ALASKAN BAY OWNER'S ASSOCIATION, INC
PO BOX 220011
ANCHORAGE, ALASKA 99522

RE: Bayshore Drive Surface Rehabilitation
100th Avenue to Discovery Bay Drive, Project No. 03-12

Thank you for the opportunity to review and comment on the Preliminary Design for Bayshore Drive Surface Rehabilitation - 100th Avenue to Discovery Bay Drive, Project No. 03-12 (65% drawings). Several members of the Alaskan Bay Owners Association (ABOA) as well as members of our association were able to review and provide feedback. This has been compiled is presented in this letter.

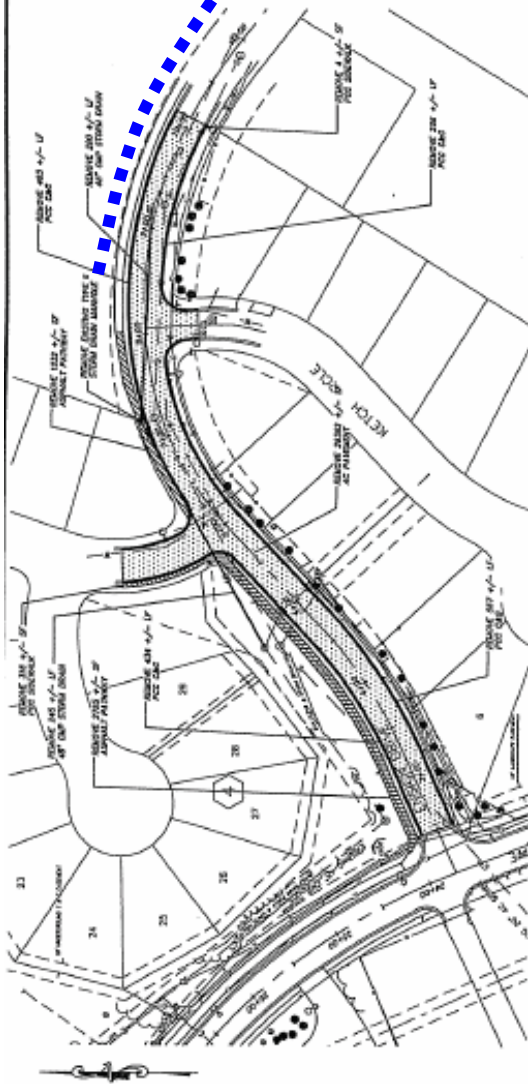
There is a habitual problem of people driving their vehicles over the curb, across the pathway and then parking on the ASD property by the ball fields across from Ketch Circle. In doing this they run over the trees and shrubs, and create a significant safety risk to pedestrians as well as vehicles. The 4-5 existing 4" bollards were installed by one of the owners on Admiralty Bay Drive in an effort to stop the vehicles from driving across the side walk. **Recommendation: install bollards along this section of Ensign to prevent this action. Additional plantings of trees would also be desirable as most of the trees have been either killed by the vehicles, or pulled out (excavated 2 falls ago and thrown into the bush on the ASD property. See Attachment 1.**

Install Bollards along Ensign, across from Ketch, to stop vehicles from driving over curb, and pathway, driving over the trees and parking on the ASD property by the ball fields.

ALASKAN BAY OWNER'S ASSOCIATION, INC
PO BOX 220011
ANCHORAGE, ALASKA 99522
Attachment 2

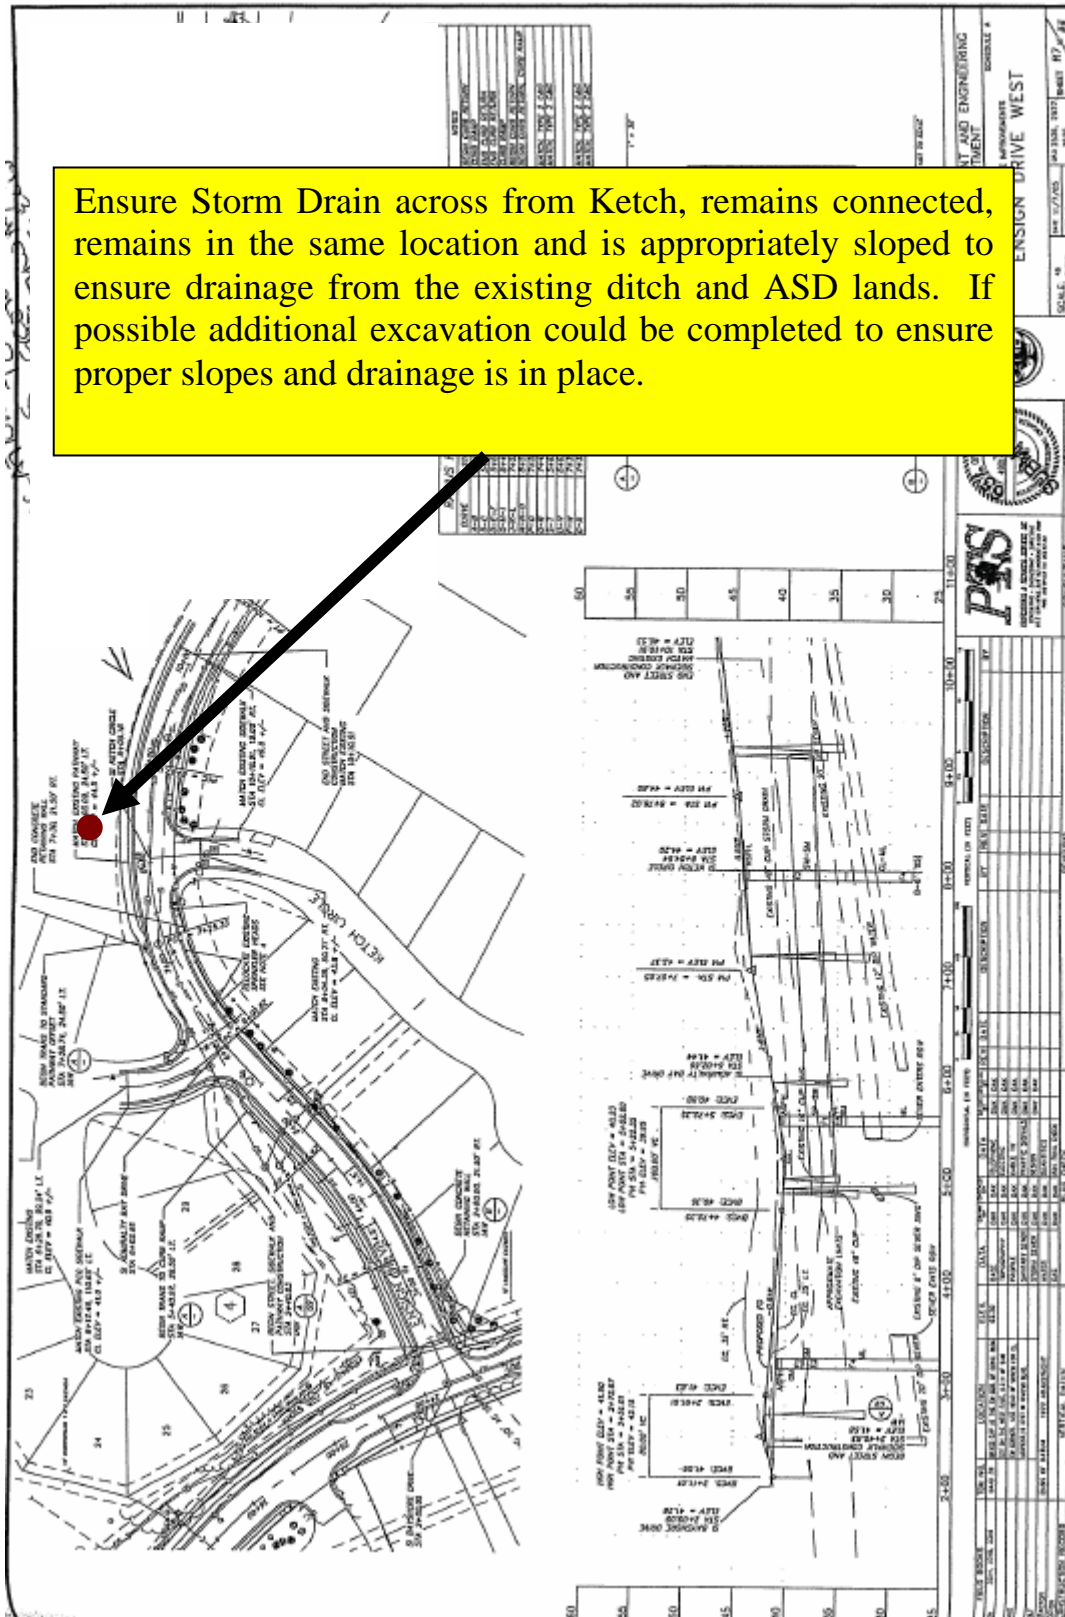
There is a storm drain on ASD property directly across from Ketch Circle that has not been depicted on the drawings. This storm drain is connected to the MOA system and provides drainage from the ASD property such that water does not infiltrate the offset owner's properties on Admiralty Bay Drive. During the past year the ABOA and the owners have been working with the ASD to have the drainage ditch cleared, as it has over grown and has seen illegal dumping, which has caused back flow issues into the ABOA properties. During this last summer this ditch was opened back up, through manual labor, and has again alleviated the water issues. This Storm Drain needs to remain in place and connected to ensure further water problems are avoided. **Recommendations: ensure SD is surveyed and included on drawings, ensure SD**

Ensure Storm Drain across from Ketch, remains connected, remains in the same location and is appropriately sloped to ensure drainage from the existing ditch and ASD lands. If possible additional excavation could be completed to ensure proper slopes and drainage is in place.

remains in place and connected to the MOA system, excavate around the SD to provide better drainage. See Attachments 2 and 3.

Attachment 4

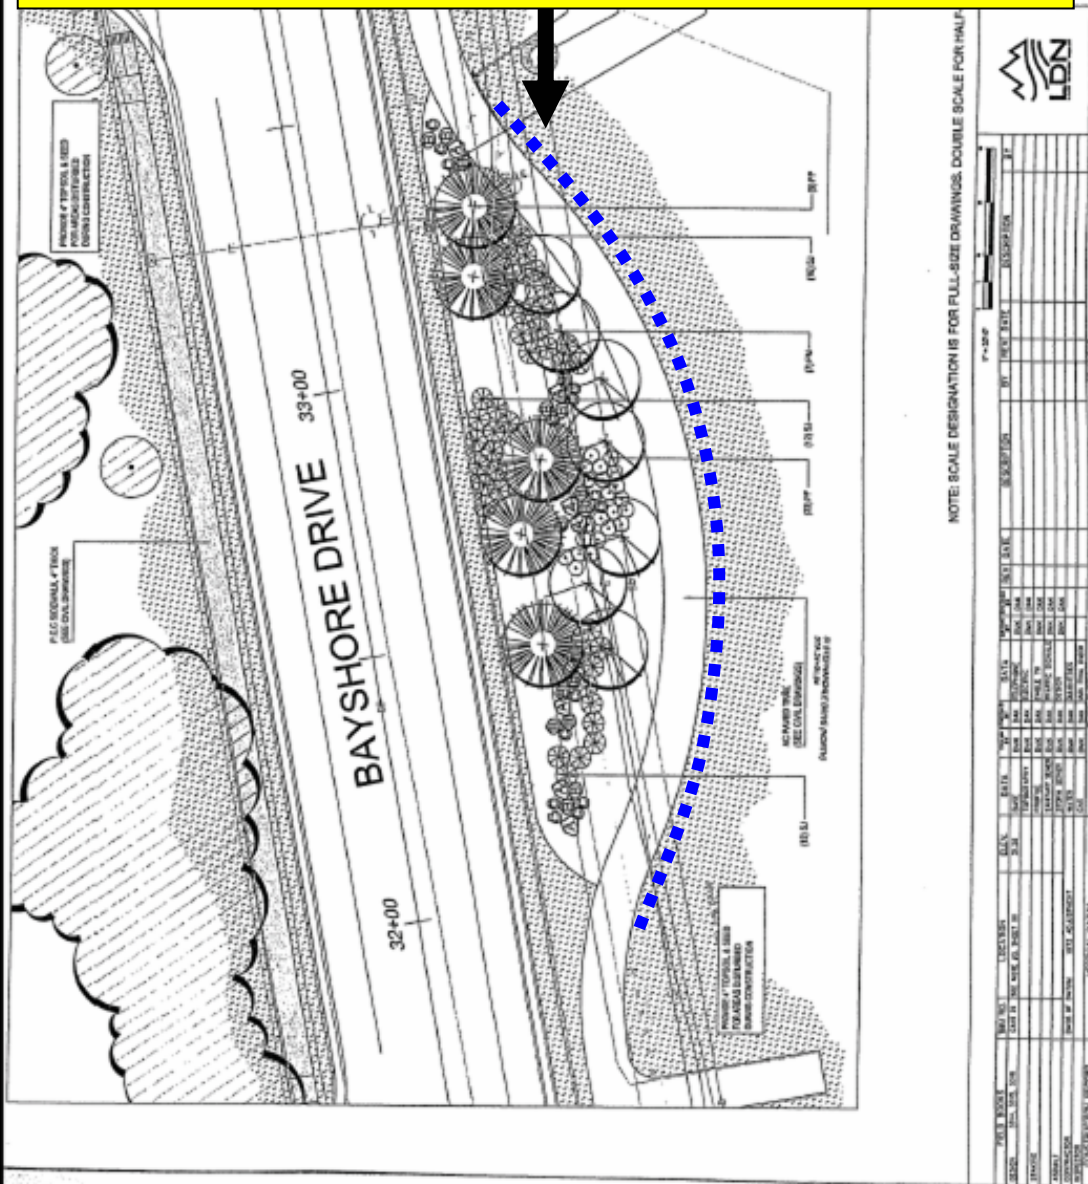
The landscaping and pathway excursion into KFQD will be a nice addition. Currently there are bollards in place along the complete length of KFQD on the Bayshore Drive side. The current design has the bollards removed along the length where the path way enters the park. Some means of blocking vehicular traffic is required at each end of the path as it extends into KFQD park, or along the length of the path way. Potential solutions include install bollards along the East side of the pathway, install large landscape rocks along the east side of the pathway, or, install a landscape wall 12-18 inches high on the east side of the pathway. **Recommendation: either install bollards similar to that currently in place, or install large landscape rock similar to those planned in other areas of the project Landscape Boulders (Type A). See Attachment 4.**

Install a landscape wall 12-18 inches high on the east side of the pathway.
